DEVELOPMENT APPLICATION NO: DA19/0875

URBIS RESPONSE TO PENRITH CITY COUNCIL REQUEST FOR ADDITIONAL INFORMATION – 27TH APRIL 2020

Response to RFI Relating to Visual Impacts

NEPEAN GARDENS, WALLACIA, NSW

DATE: 22.05.2020
JOB NO: P0014166
DWG NO: VP_B3
REV: -

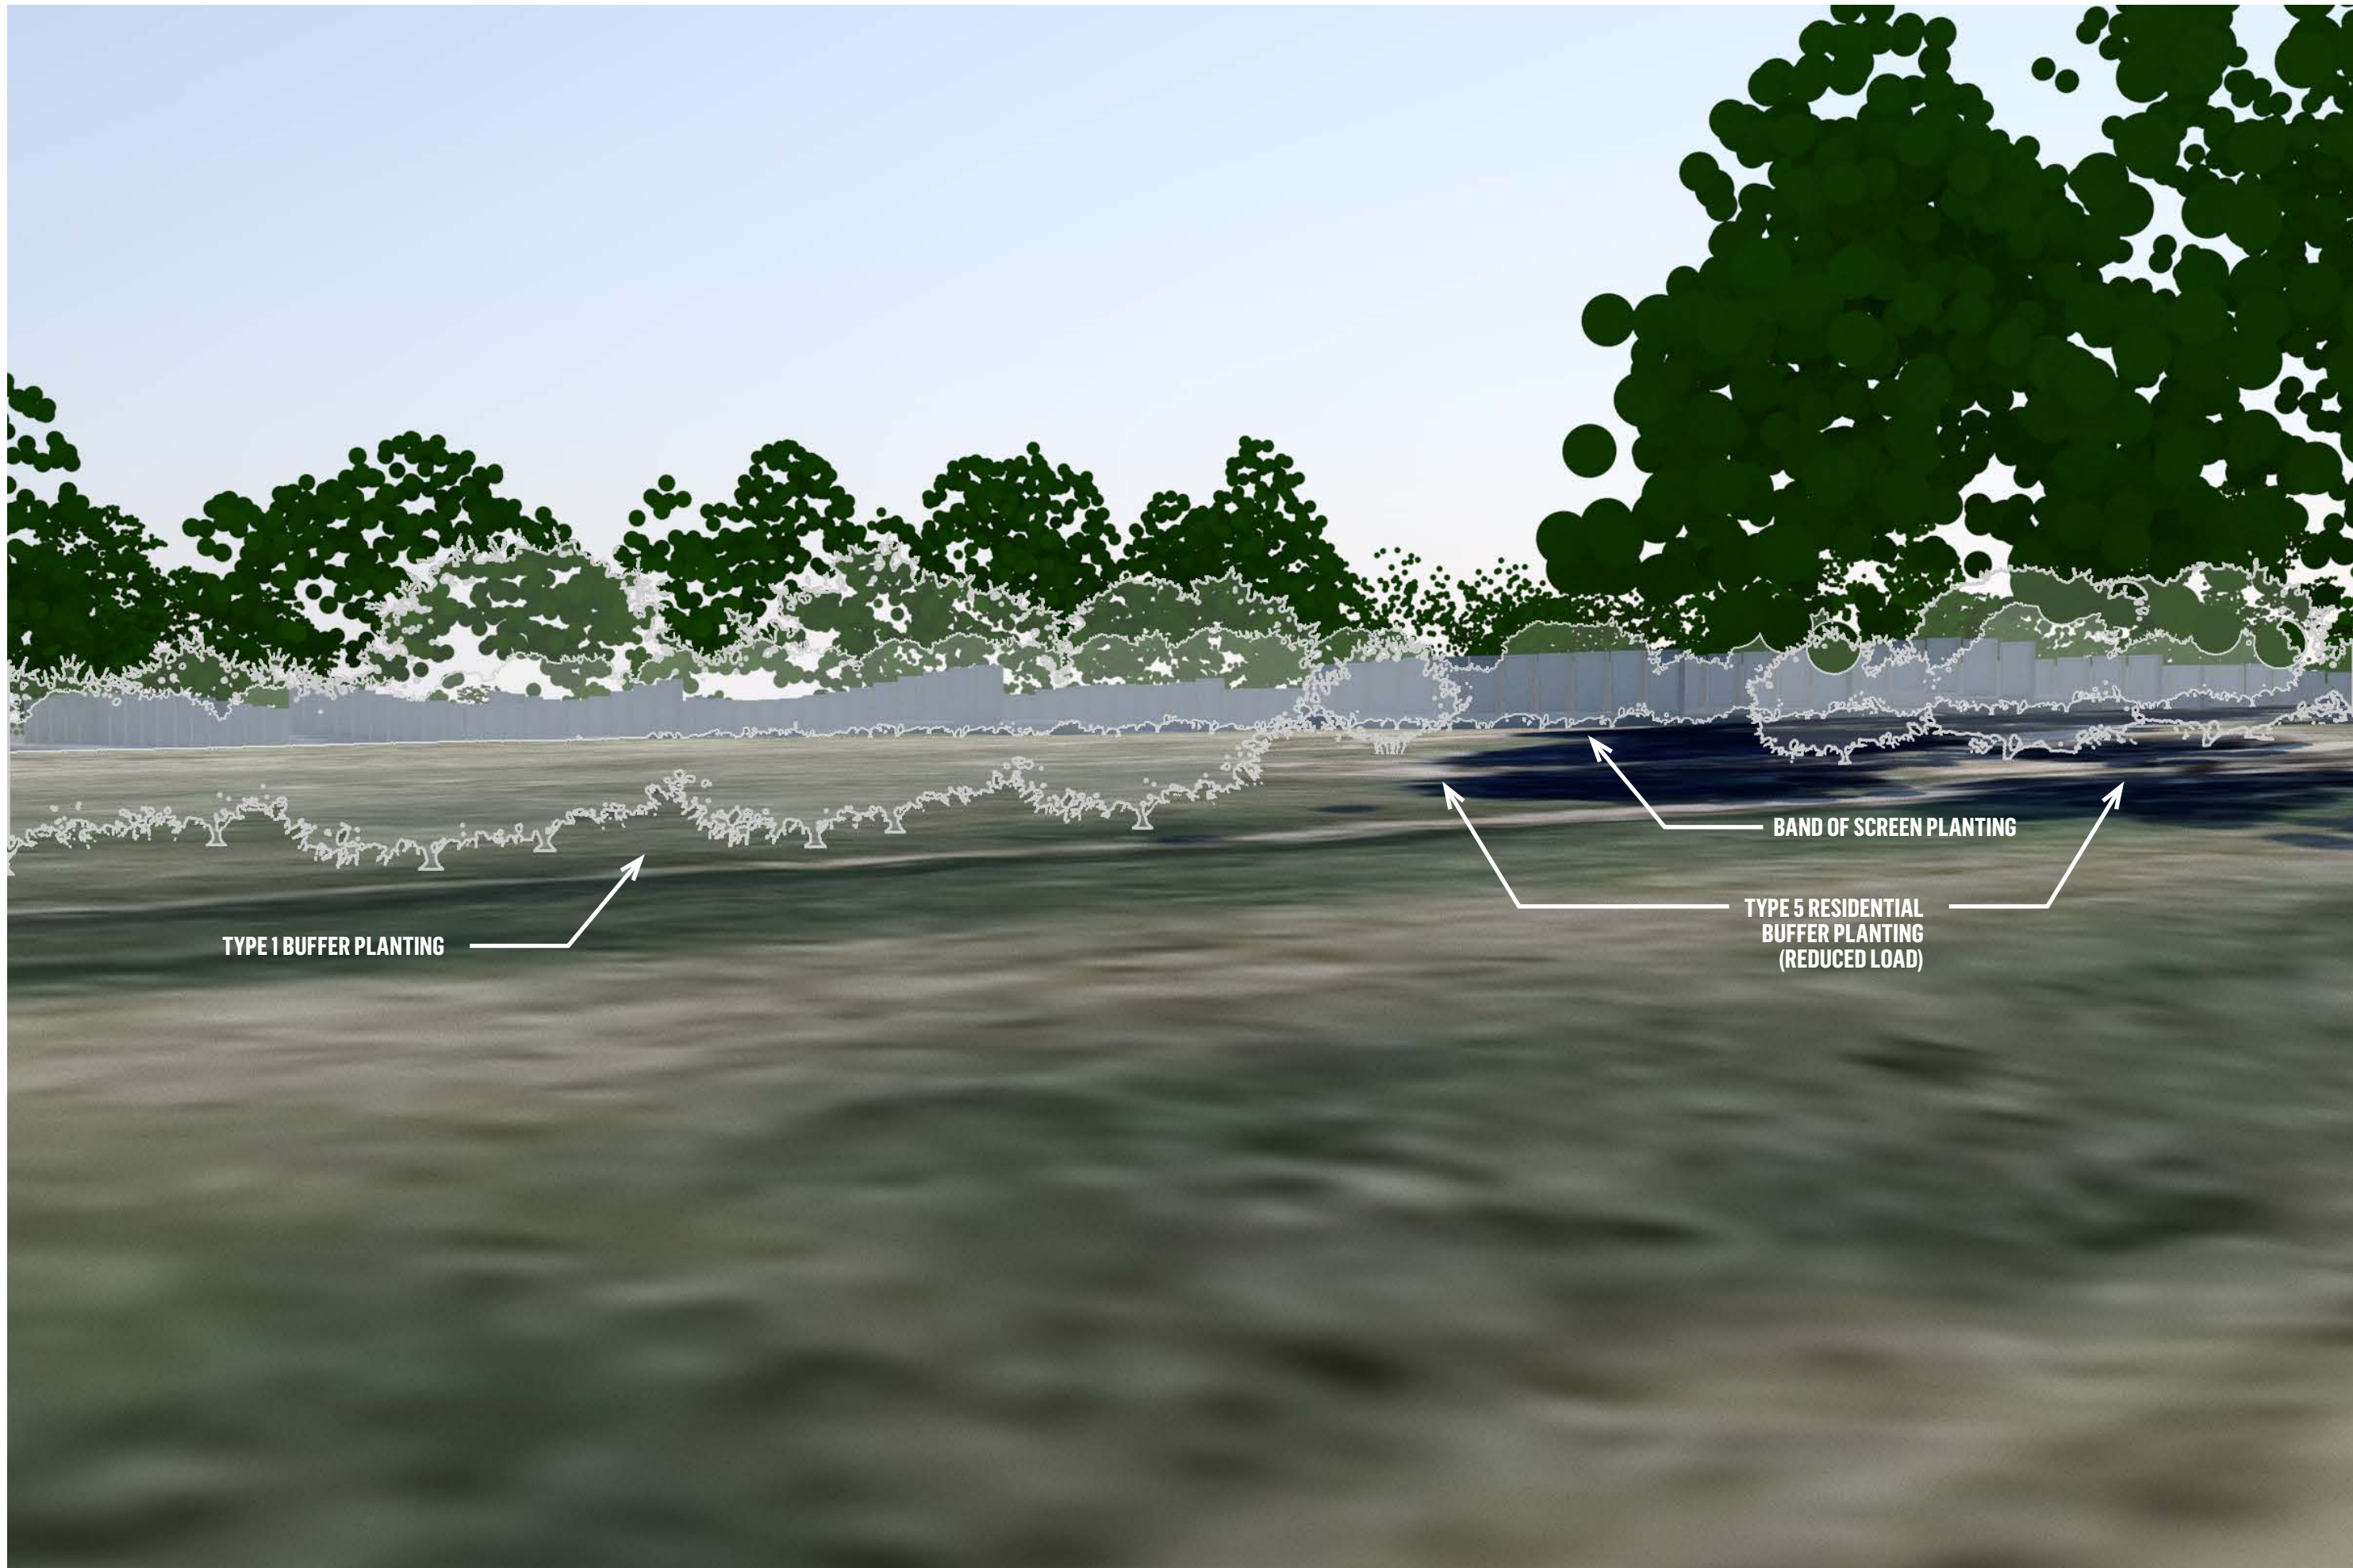
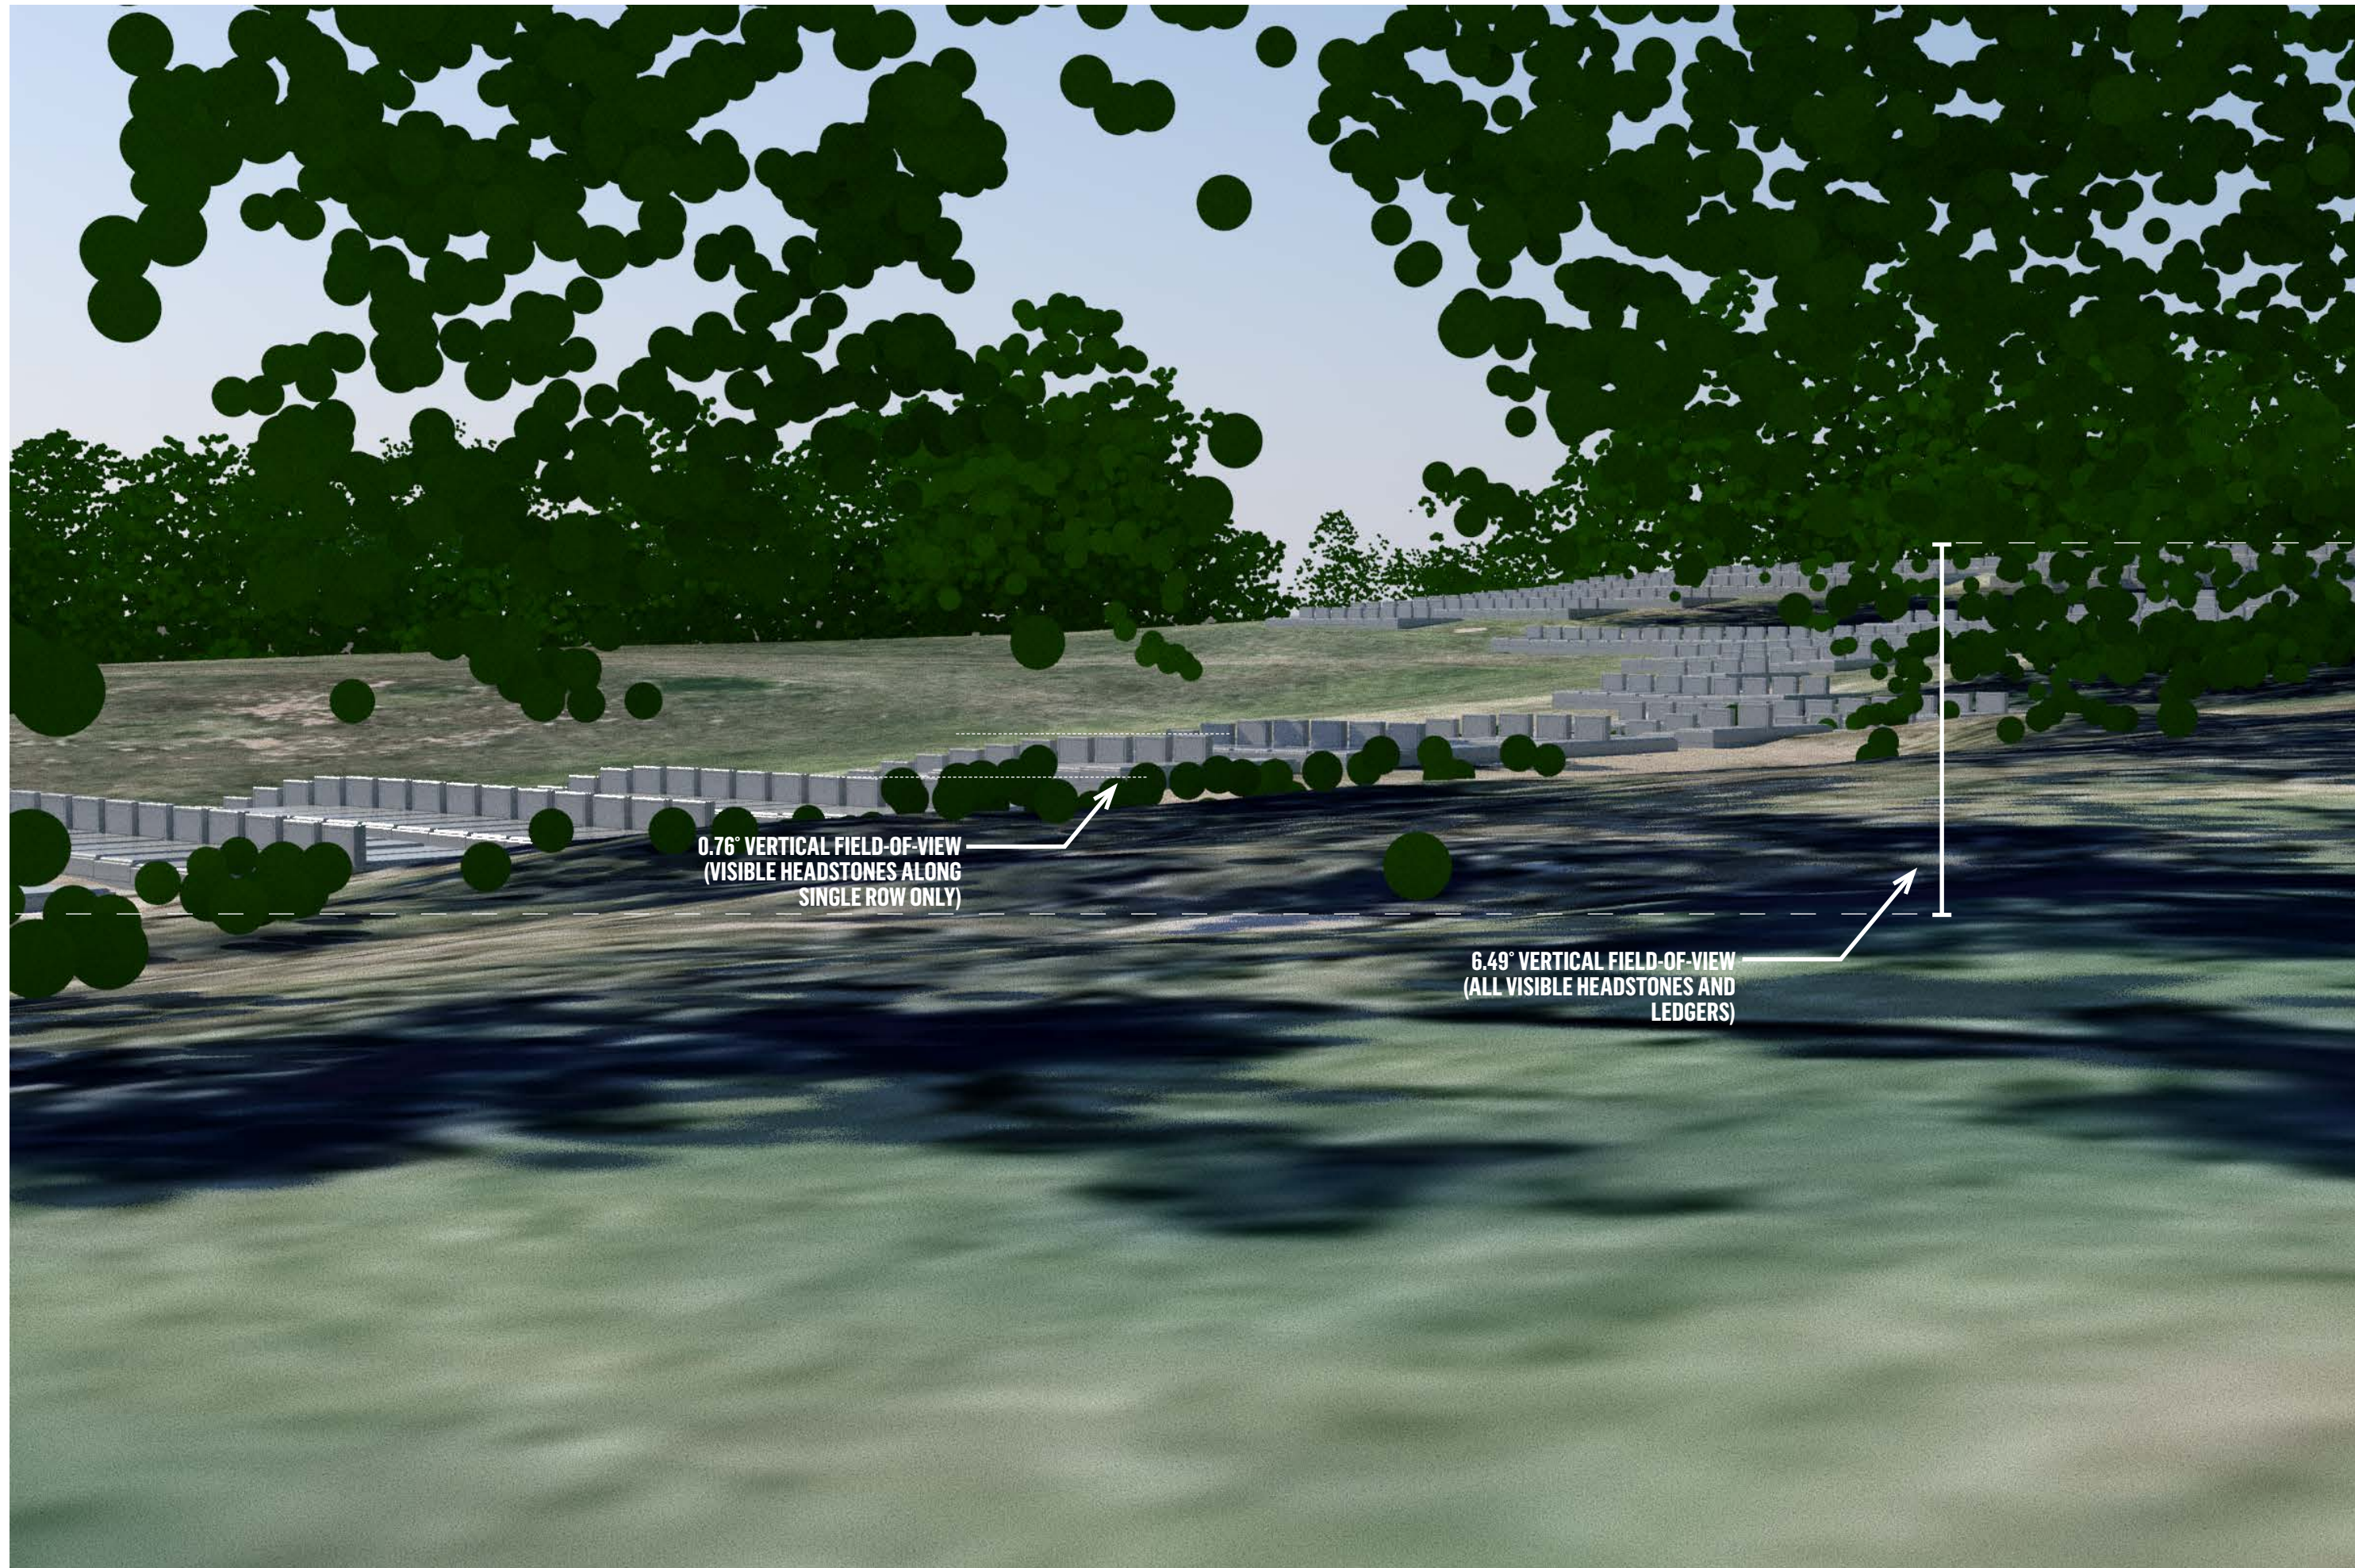
(h) The proposal for Type 3 - 1.5m high memorial head stones is likely to impact poorly on views from neighboring rural residential properties. A response is requested as to why memorial headstones should not be limited in height to 600-800mm, so as to be less visible. The impact of the proposal for Type 4 - Full monumental installations needs to be assessed and in this regard, further detail is to be provided as to the allowable dimensions and locations for this typology. A view analysis or montage may be required.

- VP A – 0.19° vs 0.52°
- VP B – 0.53° vs 1.14°
- VP C – 0.76° vs 1.23°

In all views, the buffer landscaping is highly effective at ameliorating views from surrounding areas. Given the headstones are only 1.5 m in height, buffer planting proximate to viewing location is highly effective in screening views within a relatively short period of time. Post planting, the landscape will gradually reduce views of the monuments. The computer simulations demonstrate that after 5 years, the landscaping will be of a height to effectively screen views to the tops of the monuments.
